3.5L GTDI—INTERMITTENT STUMBLE/MISFIRE ON ACCELERATION FROM HIGHWAY CRUISE IN HUMID OR DAMP CONDITIONS WITH POSSIBLE DTC

TSB 12-10-19

2011-2012 F-150

This article supersedes TSB 12-6-4 to remove the the production fix date, update the Title, Issue Statement, Part List and Service Procedure.

Figure 1 - Article 12-10-19

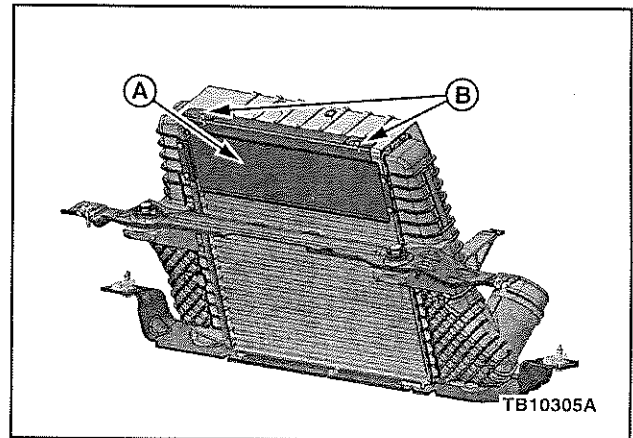
1. Check for DTC P0430. Is DTC P0430 present?
 - a. Yes - Replace the left bank catalytic converter assembly. Refer to Workshop Manual (WSM), Section 309-00. Proceed to Step 2.
 - b. No - Proceed to Step 3.
2. Is the Charge Air Cooler (CAC) equipped with an air deflector plate? (Figure 1A)

- a. Yes - Proceed to Step 5.
 - b. No - Proceed to Step 3.
3. Install a new CAC, new air deflector plate, and original shield using new retaining pushpins. Refer to WSM, Section 303-12. (Figure 1B) Proceed to Step 4.
 4. Reprogram the PCM to the latest calibration using IDS release 79.02A or higher. This new calibration is not included in the 2012.5 DVD. Calibration files may also be obtained at www.motorcraft.com.
 5. Install a new CAC and the original air deflector plate and shield using new retaining pushpins. Refer WSM, Section 303-12.
